MAINE TURNPIKE AUTHORITY

ADDENDUM NO. 2

CONTRACT 2024.01

PAVEMENT REHABILITATION

SHEET NUMBER: EQ-01

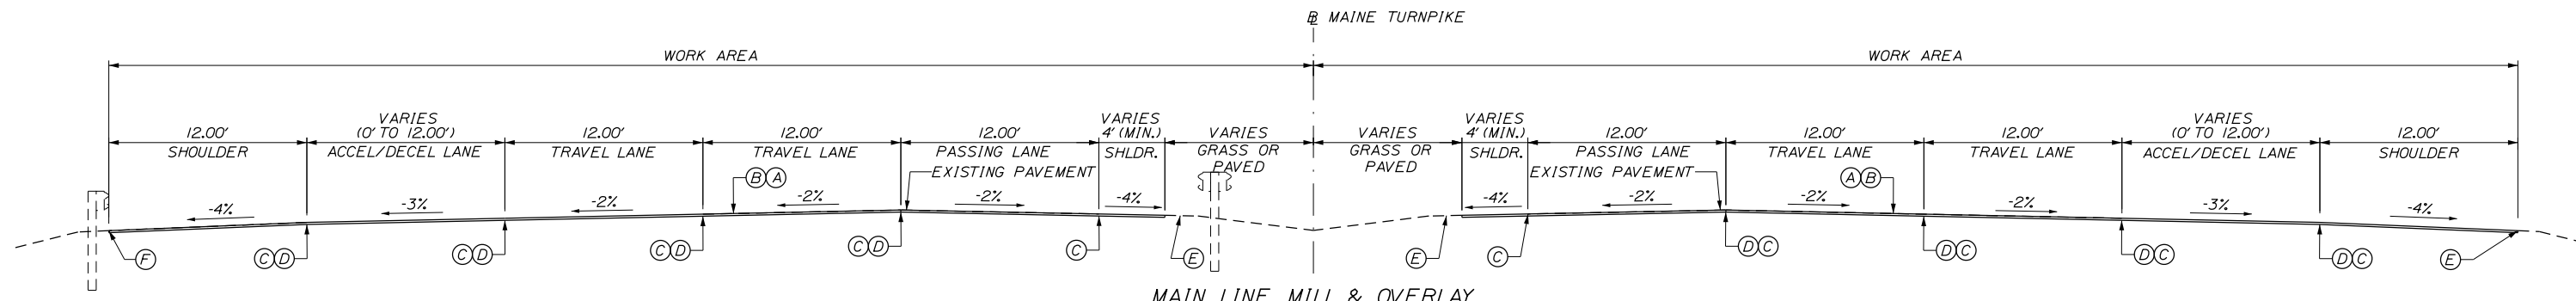
- Plan Sheet EQ-01 (2 of 40) change the quantity of item 202.2026 from 150 SF to 500 SF.
- Plan Sheet TS-01 (4 of 40) change the hot rubberized asphalt from SS-S-1401C to ASTM D6690 Type IV.
- Plan Sheet DT-04 (26 of 40) change the width of the drainage path from 18” on grade and 4 ft at sags to 4 ft on grade and 6 ft at sags. Milling depth changed from 1.5” to 1.75”.
